OPTIONAL SERVICE BULLETIN NO. OSB 40-104 REV. 0

Type: DA 40-180

Vertical stabilizer rivet nuts replacement by anchor nuts.

WORK INSTRUCTION WI-OSB 40-104 REV. 0

Figure 1. VS-HS fairing removal.

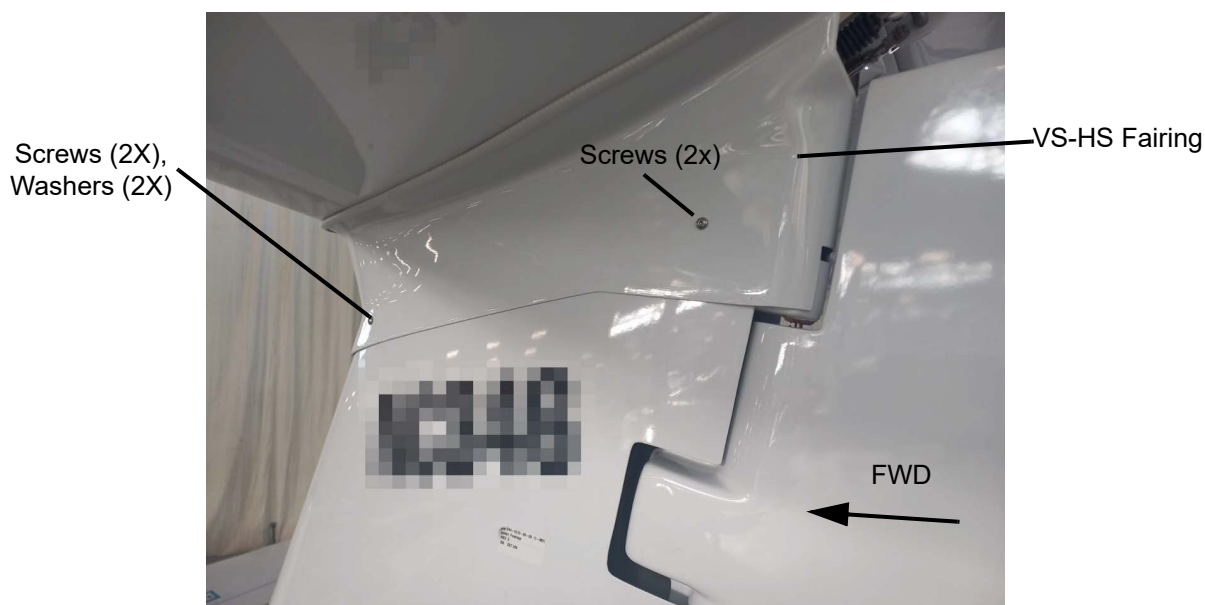
1. Remove the 4 screws and 2 washers which attach the VS-HS fairing. Refer to Figure 1.

Figure 2. Anchor nut installation.

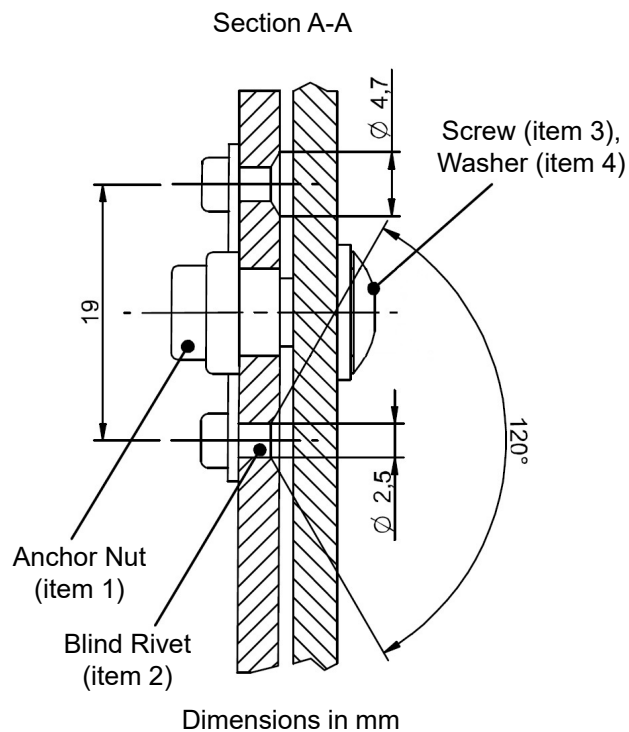
5. To install the 2 anchor nuts (item 1) at the same installation points of the rivet nuts, drill the vertical stabilizer to install the 4 blind rivets (item 2). Refer to Figure 2.

Figure 3. Anchor nuts installed on the vertical stabilizer

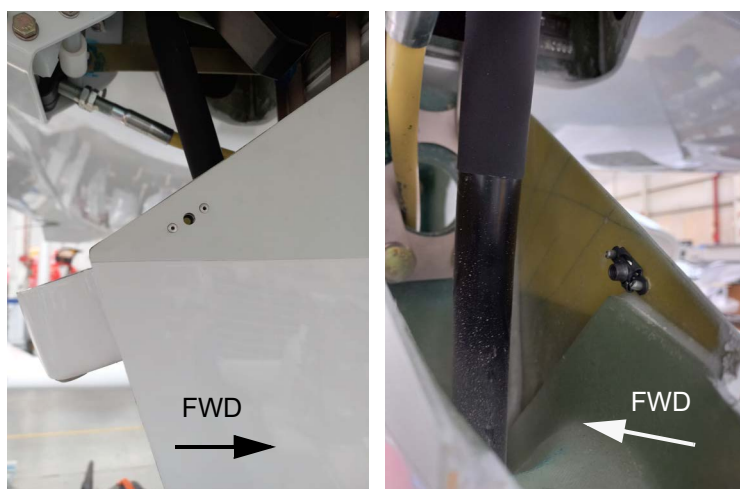
6. Install the 4 blind rivets (item 2) to attach the 2 anchor nuts (item 1) to the vertical stabilizer. Refer to Figures 2 and 3.
